**FOOD LION - ROCKWALL**  
AN ADDITION TO  
THE CITY OF  
ROCKWALL, ROCKWALL CO.,  
TEXAS  
E. TEAL SURVEY, ABST. NO 207  
SEPTEMBER, 1990

## REVIEW OF THE SITE PLAN FOR FOOD LION STORE

RE: Food Lion Site Plan

**Agenda Item:** P&Z 09-23/SP/PP - Discuss and Consider Approval of a Site Plan/  
Preliminary Plat/Building Plan for Food Lion Grocery Store

| SHEET     | LS-1      |

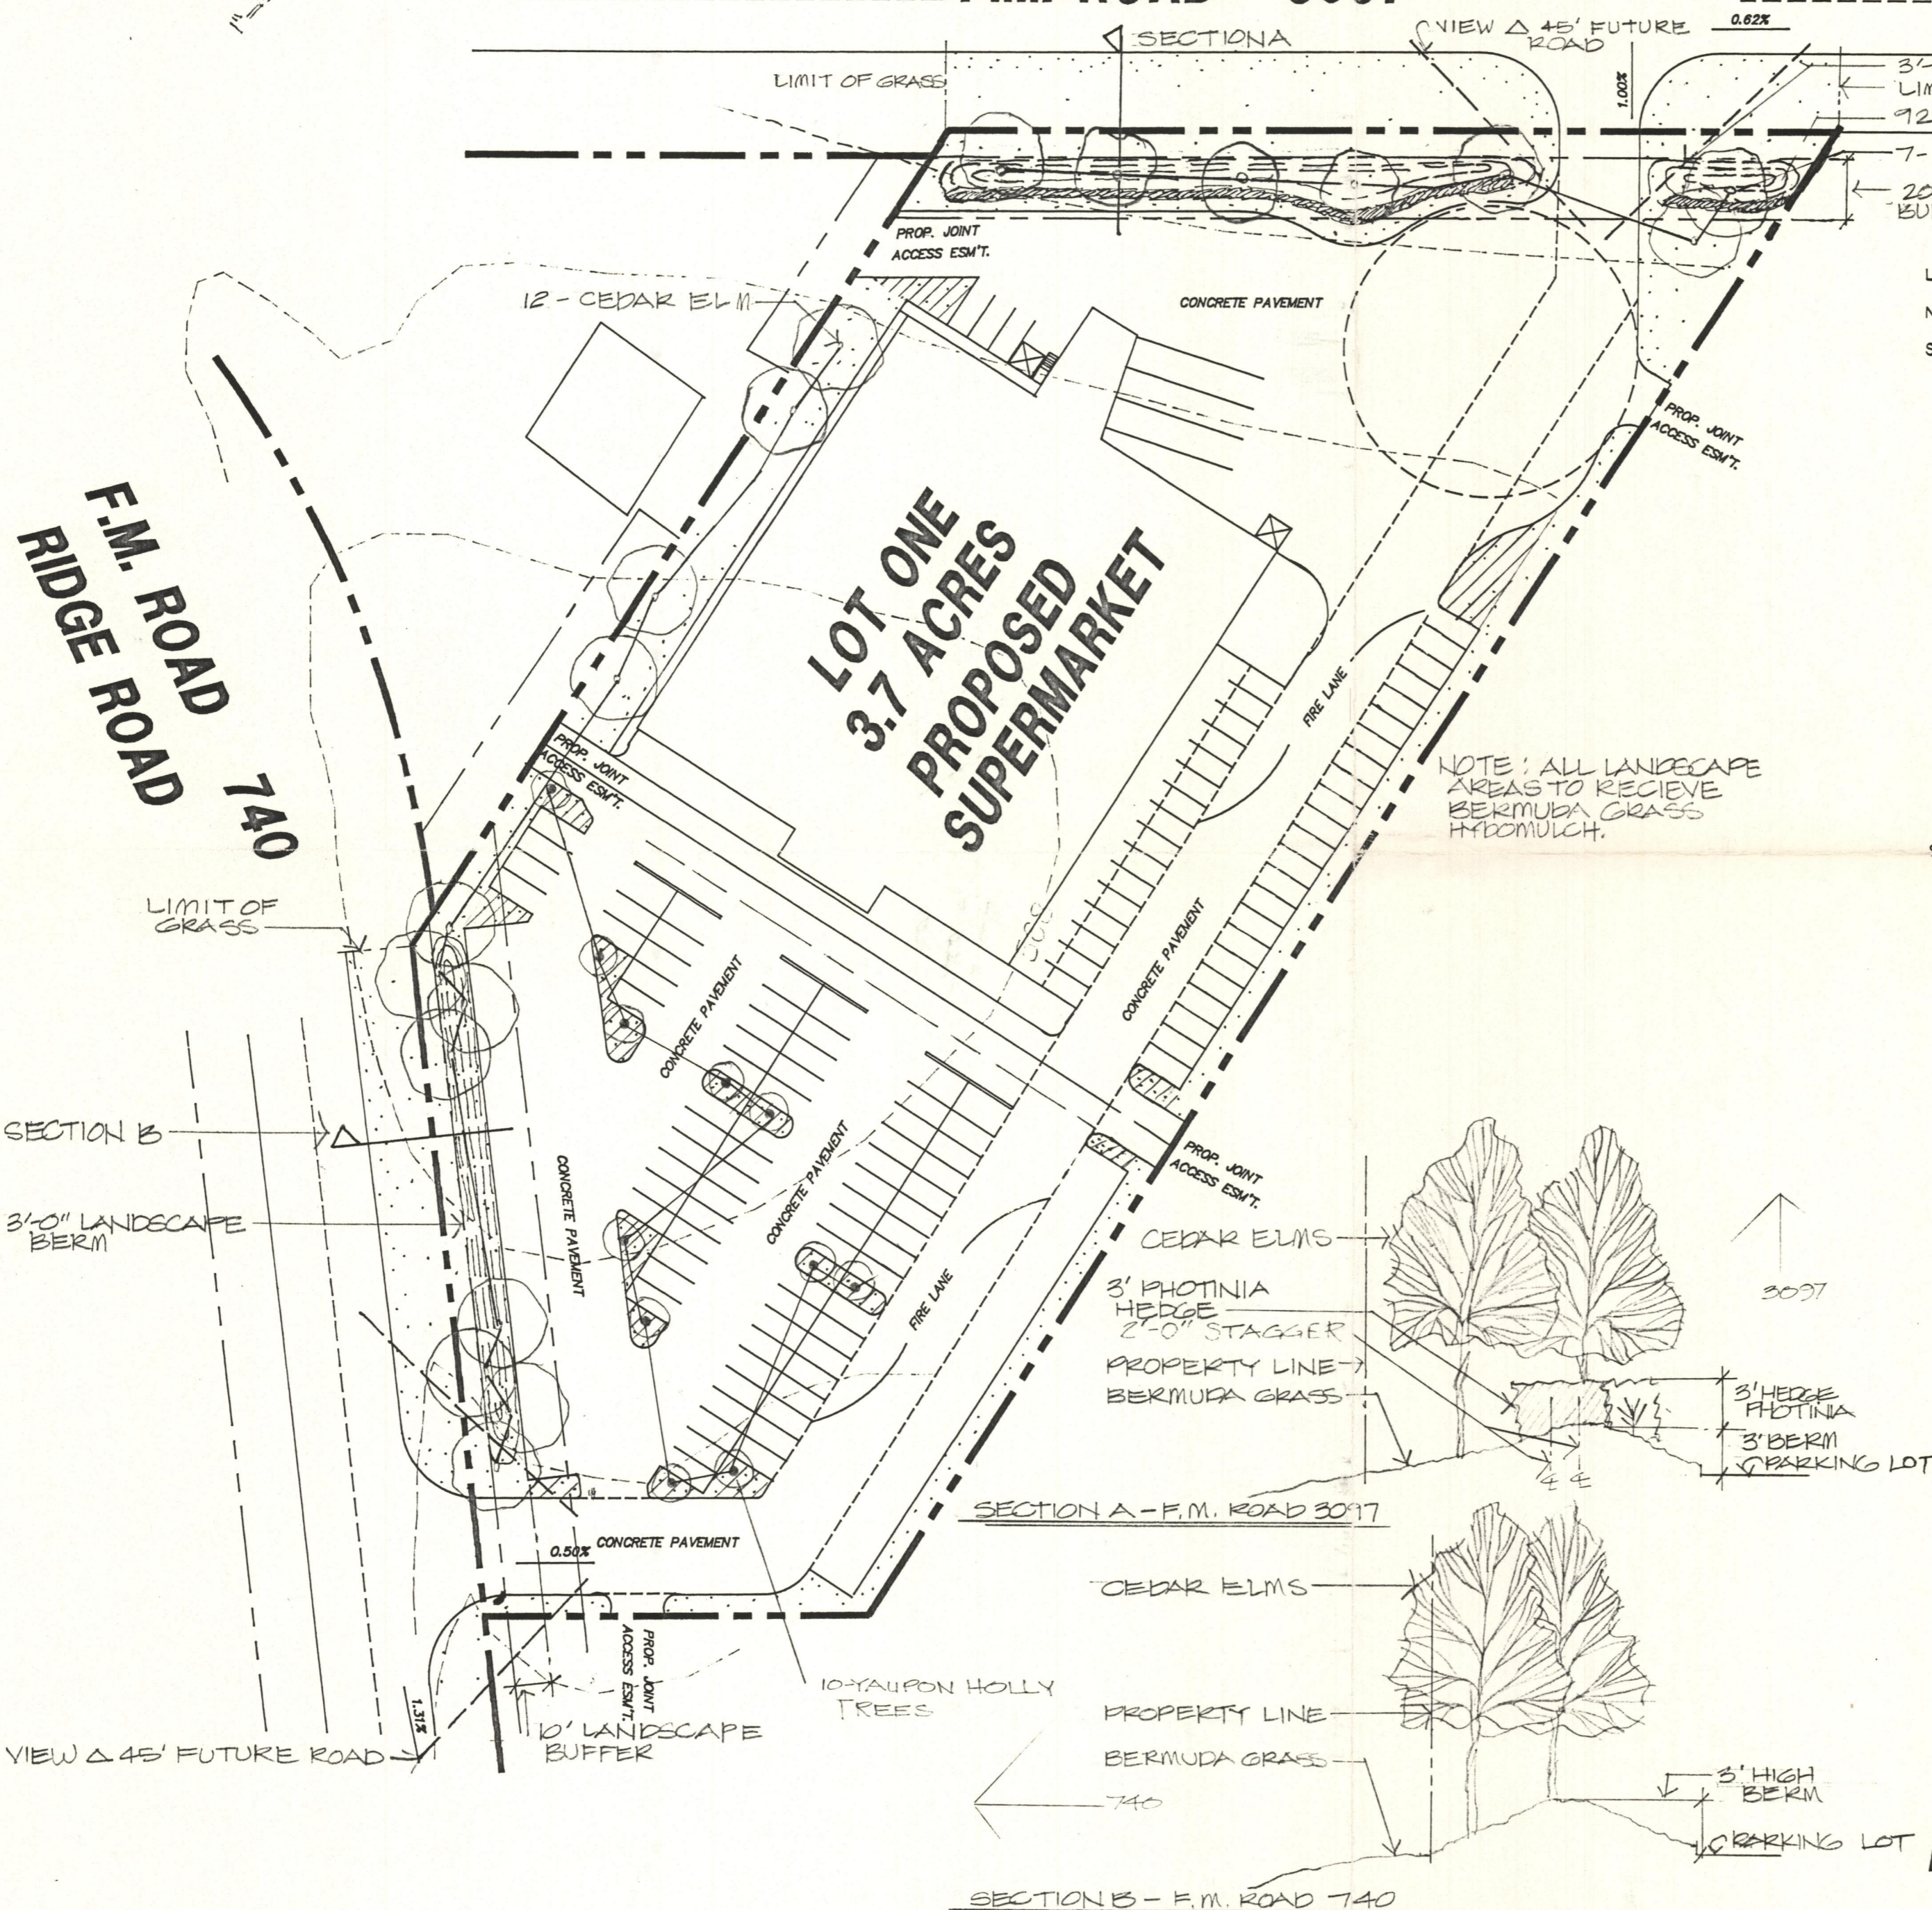
6. The additional required street trees should be placed along the north property line to provide some screening for the side of the building. The plan reviewed by the Board did not have 4 street trees included.

1. The applicant is providing 12.5% of landscaping with a credit of 2.5% for the 3' berm on FM-740 and FM-3097. They need to adjust the landscaping in the interior of the parking lot to provide 5% in landscaping. They are currently only providing approximately 2.5%.
2. They need to provide additional trees along the street frontages. They are required to have trees equal to 1 per 30 feet in the OV district and they are only providing 1 per 50 feet. They are requesting approval to not use that many trees in the front because it blocks the view of the building from the street.

The developer has included these additional trees in the revised site plan.

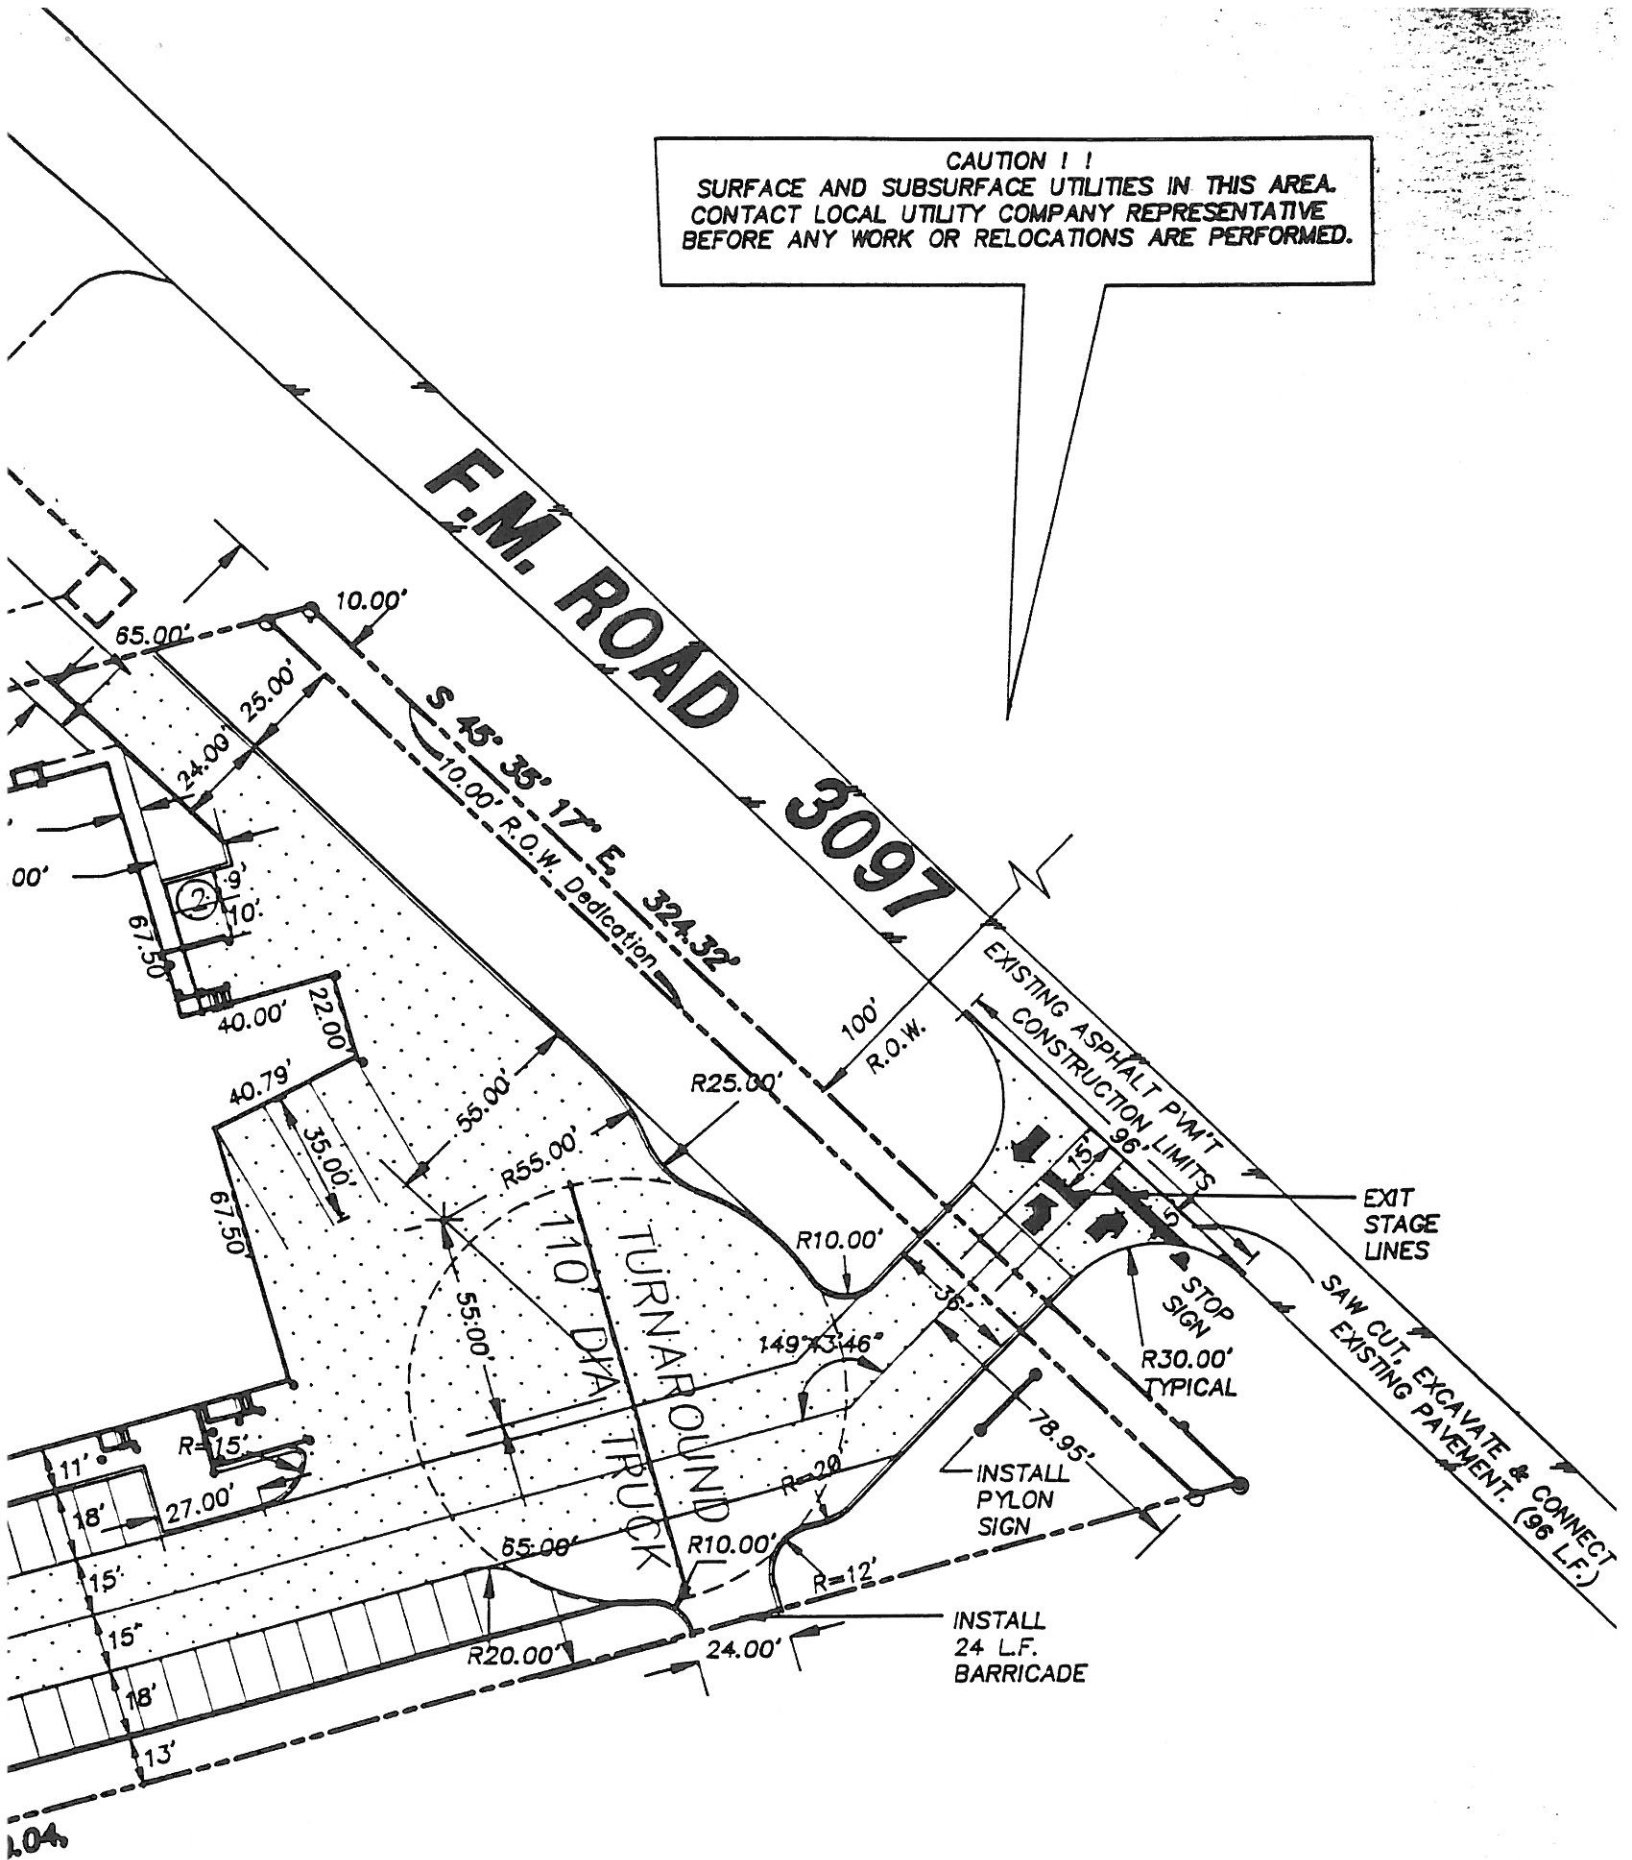
In follow up to our telephone conversation last week I would like this letter to serve as a request in considering a 36.00 foot wide drive in lieu of a 30.00 foot wide drive at our project entrance off of F.M. 3097. The attached exhibit shows the requested widening. This request was prompted by the Site Developer in order to provide better patron and truck accessibility off of F.M. 3097. This drive widening along with the proposed widening of F.M. 740 should greatly entrance the traffic conditions at the F.M. 740 site entrance. Although we do not intend to restrict truck traffic from the F.M. 740 drive we do anticipate the more convenient truck entrance and exit condition to be at F.M. 3097. Thus relieving the storage and exiting condition at the F.M. 740 Drive.
